Project: Columbus Metropolitan Library Technology Cabling Phase 4 CML 17-027

RE: Information Letter #1

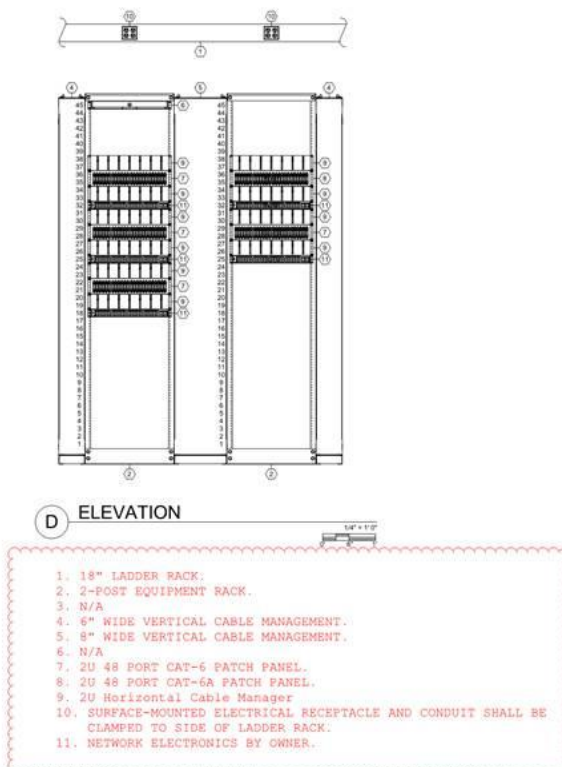
1. Question: Drawing T301 detail D has does not have a schedule for all of coded notes.

Answer: The following notes should have been included; (see sketch below)

- 1. 18" LADDER RACK.*
- 2. 2-POST EQUIPMENT RACK.*
- 3. N/A*
- 4. 6" WIDE VERTICAL CABLE MANAGEMENT.*
- 5. 8" WIDE VERTICAL CABLE MANAGEMENT.*
- 6. N/A*
- 7. 2U 48 PORT CAT-6 PATCH PANEL.*
- 8. 2U 48 PORT CAT-6A PATCH PANEL.*
- 9. 2U Horizontal Cable Manager*
- 10. SURFACE-MOUNTED ELECTRICAL RECEPTACLE AND CONDUIT SHALL BE CLAMPED TO SIDE OF LADDER RACK.*
- 11. NETWORK ELECTRONICS BY OWNER.*
